SUBJECT: Riverbend Wind Energy Comments on New Proposed Ordinance

Re: Review of Proposed Ordinance Changes with Respect to Noise

**RE: Review of Wind Energy Conversion Systems, Proposed Zoning Ordinance Amendment to – with Respect to Shadow Flicker**

**RE: Review of Township of Fremont Zoning Ordinance Amendment to Wind Energy Conversion Systems (WECS) with Respect to Public Health & Safety**

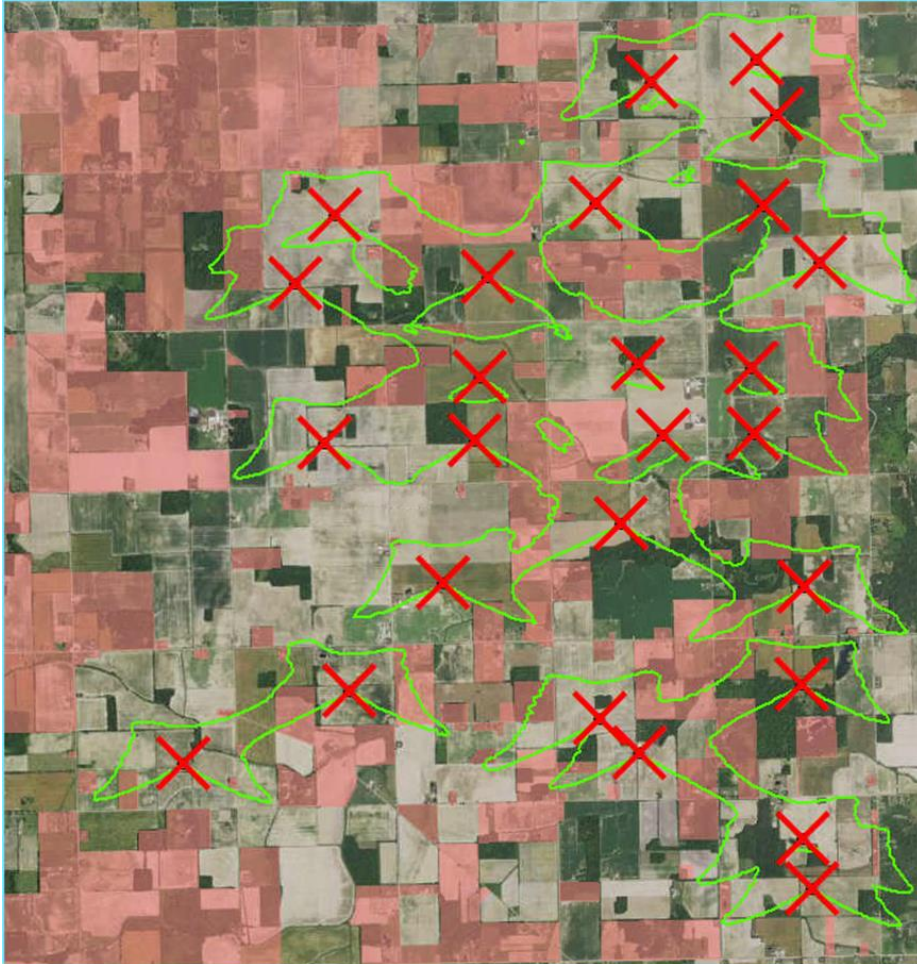
In summary, the restriction of no shadow flicker on a non-participating property line would not further the protection of the health or safety of the Township inhabitants; however, it would have the effect of stopping future wind development within the town's borders, if imposed

The effect of restricting shadow flicker on adjacent non-participating properties would render all proposed turbine locations (red X's depicted below) non-viable:
